**Subject: Beaver Valley Power Station, Unit No. 1  
BV-1 Docket No. 50-334, License No. DPR-66  
Response to a Request for Additional Information (RAI dated  
September 28, 2005) in Support of License Amendment Request No. 320**

## **L-05-165 Enclosure 1**

### **Non-Proprietary Responses to RAI dated September 28, 2005**

#### **REPLACEMENT STEAM GENERATORS (RSGs) LICENSE AMENDMENT REQUEST (LAR)** **AND EXTENDED POWER UPRATE (EPU)**

Figure 2-1

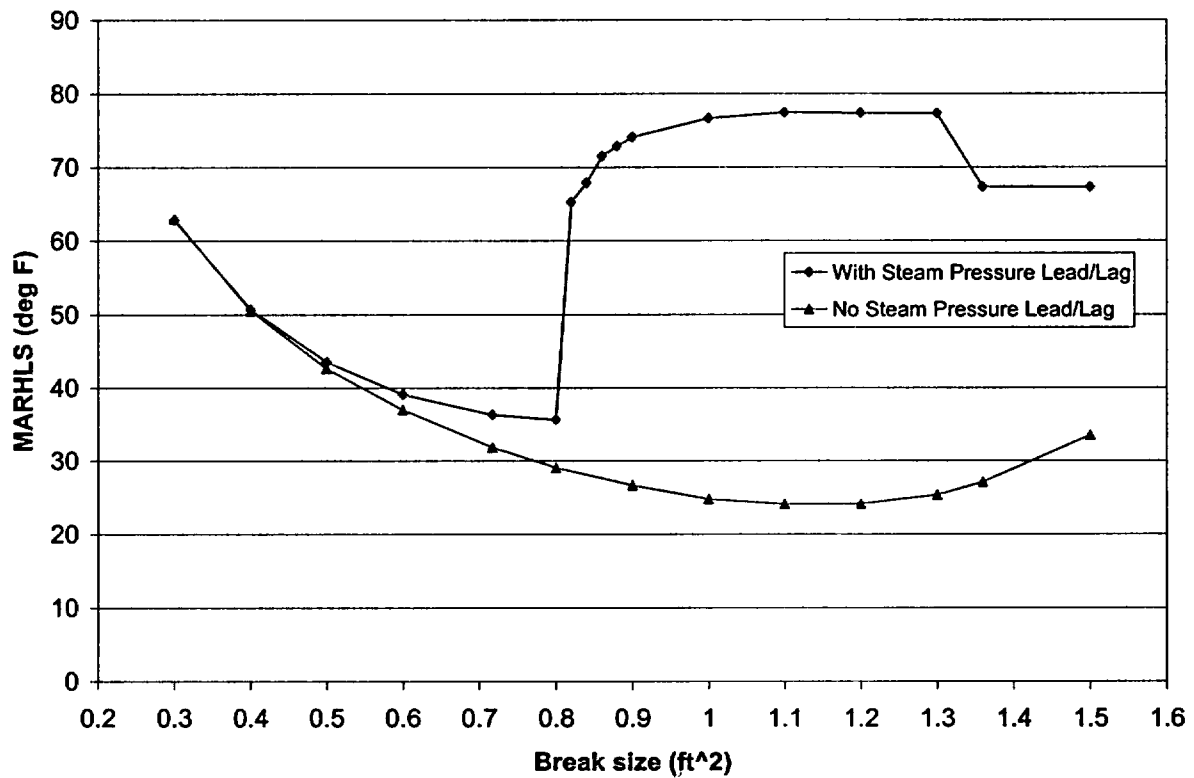
### 2. Provide a break spectrum analysis to identify the limiting break size.

Figures 2-1 and 2-2 provide the requested break size spectrum results for the BVPS units. The results show that acceptable analysis results are obtained for all break sizes up to and including a break equivalent to the feedwater inlet nozzle.

Figure 2-1 shows the margin to hot leg saturation (MARHLS) as a function of break size during the post-trip heatup. Note that the upper line on Figure 2-1 credits the lead-lag on low steam pressure to provide earlier steamline isolation and the lower line on Figure 2-1 does not credit the lead-lag. The shape of the curve is dominated by the very conservative density feedback assumptions made in the analysis. With the larger break sizes, the cool down effects and the resultant core criticality and power generation become significant. The very conservative density feedback assumptions are based on pre-trip conditions and do not account for the reduced feedback conditions that would be experienced post-trip with the most reactive control rod stuck out of the core. This results in a premature prediction for return-to-critical conditions and artificially limits the cool down and maximizes the heat addition to the RCS compared to what would actually occur. It is worth noting that more realistic post-trip reactivity feedback assumptions would increase the margin to subcooling by more than 30 degrees, and therefore the cases presented in the submittals remain bounding with respect to sub-cooling margin.

Figure 2-3

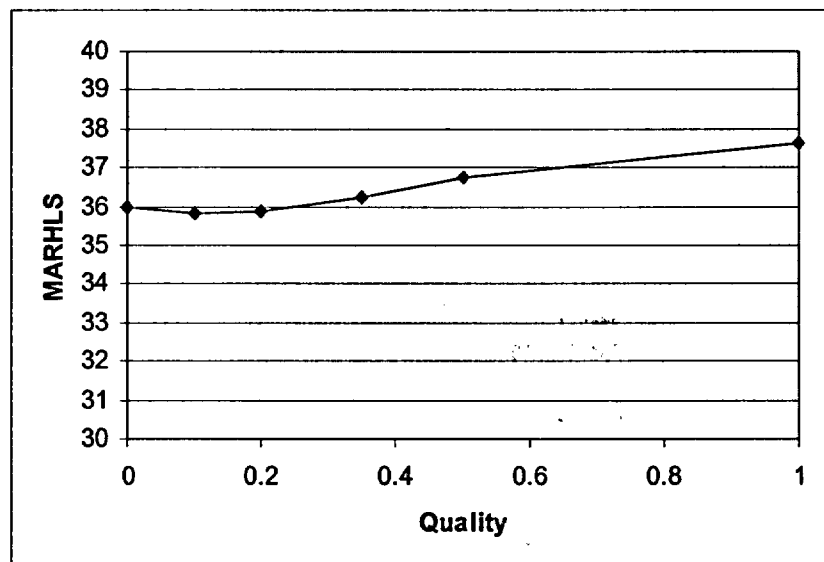
- 6. With regard to the use of the "more detailed SG design codes," describe their use and interaction with LOFTRAN and RETRAN codes and discuss the licensing history and approval of these codes.**

Figure 2-3 shows that acceptable analysis results are obtained for the BVPS units regardless of the assumed break discharge quality. The case represented in the plot is the limiting BVPS-2 case (0.717 ft<sup>2</sup> break, with offsite power available) with the break quality from the time the feeding uncovers until dryout varied from zero (saturated steam) to one (saturated water).

**Figure 5-1**  
**Pressurizer Level**

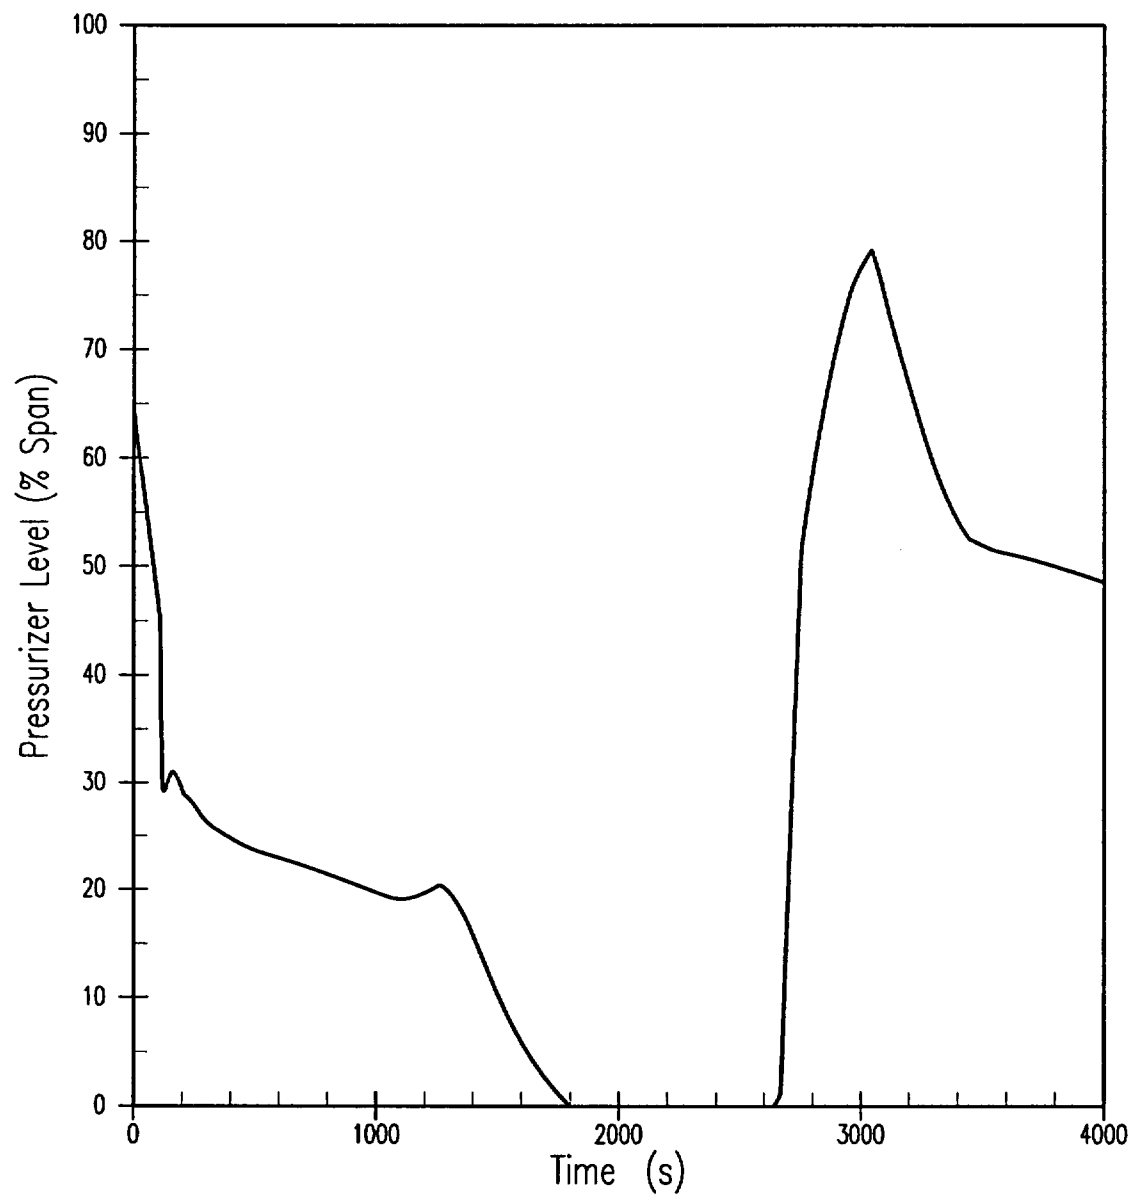
**Section 5.4 of the April 13, 2005, RSG LAR states that an operational response analysis of steam generator tube rupture (SGTR) was performed for BVPS-1. The NRC staff requests that the licensee provide a table listing the sequence of events and times from break initiation to event termination that shows operators can terminate the break flow from the ruptured SG within 51 minutes of accident initiation for the SG replacement and extended power uprate (EPU) conditions. Additionally, the staff requests that the licensee provide the results of the SGTR thermal-hydraulic analysis over time showing the pressurizer pressure, intact and ruptured SGs pressures, and ruptured SG water volume for the analysis to demonstrate that no overfilling of the SG occurs.**

The SGTR operational response analysis for EPU conditions with RSG included cases to provide thermal-hydraulic tube rupture data for use in radiological dose consequence analysis and for evaluation of margin to overfill. The sequence of events for these cases are shown in Tables 5-1 and 5-2, respectively. The sequence of events tables show that termination of the event (i.e., termination of primary-to-secondary break flow) occurs at 3652 seconds (approximately 61 minutes) and 3578 seconds (approximately 60 minutes), respectively, for EPU conditions with RSGs. Figures 5-1 through 5-6 show the response of pressurizer level, pressurizer pressure, intact and ruptured SG pressure, intact loop RCS temperatures, primary-to-secondary break flow, and ruptured SG water volume for the margin to overfill case. The response to Question 6 provides information regarding the analysis performed in the 1990's for current power conditions that established a break flow termination time of 51 minutes.
